# UNITED STATES PATENT AND TRADEMARK OFFICE

<b>Office Action Summary</b>	<b>Application No.</b> 10/576,197	<b>Applicant(s)</b> WATANABE, TOSHI
	<b>Examiner</b> KRISTEN C. HAYES	<b>Art Unit</b> 3643

**DETAILED ACTION**

**Modified Figure 1, US 5,666,904**

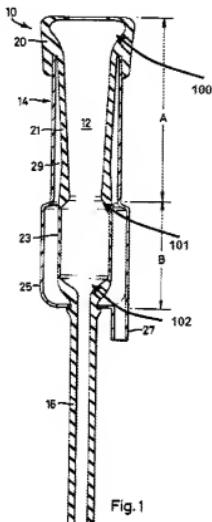
6. Regarding claim 1, Grindal discloses a teat cup for laboratory animals wherein one side of the teat cup is attached to the udder of a laboratory animal (Grindal, abstract), through suction and the other side of said teat cup is connected to a negative-pressure generating source via a milk collecting container (Grindal, column 1: line 18) with said teat cup comprising a first conical portion (100), a second conical portion (21) continuous from the first conical portion, a third conical portion (101) continuous from the second conical portion, a cylindrical teat holding portion (23) continuous from the third conical portion and a connecting portion (16) which is connected (as best understood) on the side of the negative-pressure generating source, wherein the second conical portion, the third conical portion, and the teat holding portion are dimensioned slightly larger than the actual sizes of the conically bulging portion of the udder, said teat base portion, and the teat of the laboratory animal to be milked.

7. Regarding claim 2, Grindal further discloses the teat holding portion includes a region with an increased cross-sectional area (as best understood) near where the tip of the teat is to be located (Grindal, Figure 1).

8. Regarding claim 3, Grindal further discloses the teat holding portion comprises a conical surface (102) that becomes narrower toward the tip thereof.
